2. AMENDMENT/MODIFICATION NO. 0001	3. EFFECTIVE DATE 01/25/02	4. REQUISITION/PURCHASE REQ. NO. W38XGR-1332-8907	5. PROJECT NO. <i>(If applicable)</i>
6. ISSUED BY CODE B1P0100		7. ADMINISTERED BY <i>(If other than Item 6)</i> CODE	
DEPARTMENT OF THE ARMY CORPS OF ENGINEERS, MEMPHIS DISTRICT 167 N. MAIN ST., B202 MEMPHIS, TN 38103-1894		See Item 6

14. DESCRIPTION OF AMENDMENT/MODIFICATION *(Organized by UCF section headings, including solicitation/contract subject matter where feasible.)*
 This solicitation is for Ditch 66, Channel Clearing, Dunklin & Pemiscot Counties, Missouri, scheduled to open 05 Feb 02, at 2:30 p.m.

LOWER DITCH NO. 66
CHANNEL CLEARING
DUNKLIN AND PEMISCOT COUNTIES MISSOURI
FILE NUMBER 001A0670 – 011A0670

SAFETY SIGN

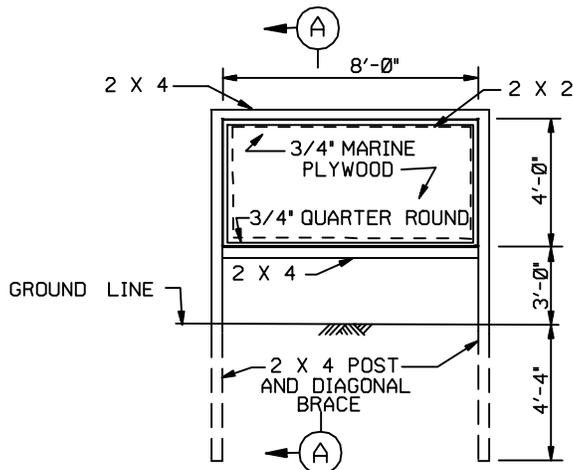
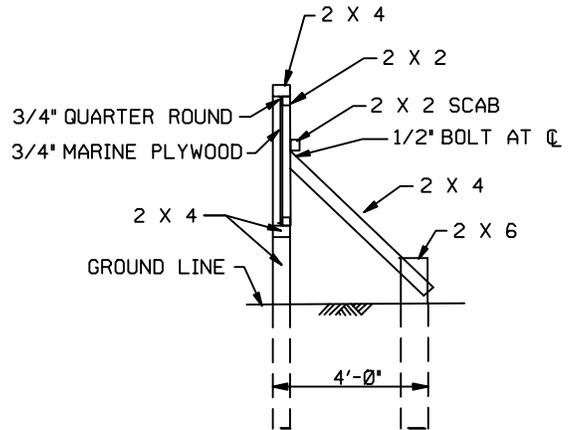
4. SECTION 00800. Add Safety Sign at the end of Section 00800.
